# CAAC 适 航 指 令

编号: CAD2008-B737-02

一. 标题: 修订检查方案

"TURBINE REAR FRAME WITH TANGENTIAL STRUTS – MANDATORY INSPECTIONS – LIFE LIMITS  $\overline{\ }$

Figure 805

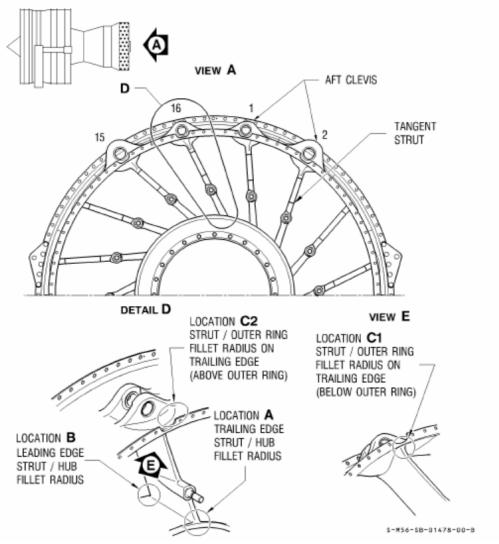
A、在本指令生效后的30天内,修订航空公司(包括公务机公司和航空承运人)的发动机单元体的适用的检查方案,增加本指令规定的强制检查间隔;修订CFM56-7B发动机车间手册(Engine Shop Manual)CFMI-TP-SM.10的适航限制部分(ALS)(05-21-03章)增加下述内容:

- C. Turbine Rear Frame Part Numbers 340-166-205-0, 340-166-206-0, 340-166-207-0, 340-166-208-0, 340-166-209-0, 340-166-210-0, for all CFM56-7B SAC engine models (except -7B27A engine models). Refer to figure 805.

Figure Index No.	Inspection Location	Inspection Threshold (Cycles since new)	Inspection Intervals (Cycles)	Inspection Reference
805	Strut/outer ring fillet radius on trailing edge (A)	25,000* for -7B SAC (except business jet) engine models	Refer to Figure 806* for -7B SAC (except business jet) engine models	Refer to SB 72-0579*
	Strut/hub fillet radius on leading edge (B)	19,000* for -7B SAC business jet engine models	Refer to Figure 807* for -7B SAC business jet engine models	
	Strut/outer ring fillet radius on trailing edge (C1 below outer ring)			
	Strut/outer ring fillet radius on trailing edge (C2 above outer ring)

If inspection is not performed, part must be removed.

If no crack is found on any of the four mount struts, the turbine rear frame is serviceable and must be re-inspected at 4,700 cycle repetitive intervals. If cracks are found on the mount struts, the TRF must be re-inspected according to the following repetitive intervals:

TOTAL CUMULATED CRACK LENGTH AT EACH LOCATION	RE-INSPECT WITHIN
L < 0.20 (5)	4,700
$0.20(5) \le L < 0.28(7)$	3.300
$0.28(7) \le L < 0.39(10)$	1,300
$0.39 (10) \le L < 0.59 (15)$	700
$0.59 (15) \le L < 0.79 (20)$	120
$L \ge 0.79 \ (20)$	IMMEDIATELY REMOVE THE TURBINE FRAME

During each inspection, all the locations must be inspected. If cracks are found at different locations, the repetitive inspection interval is the minimum interval corresponding to the max. cumulated crack lengths.
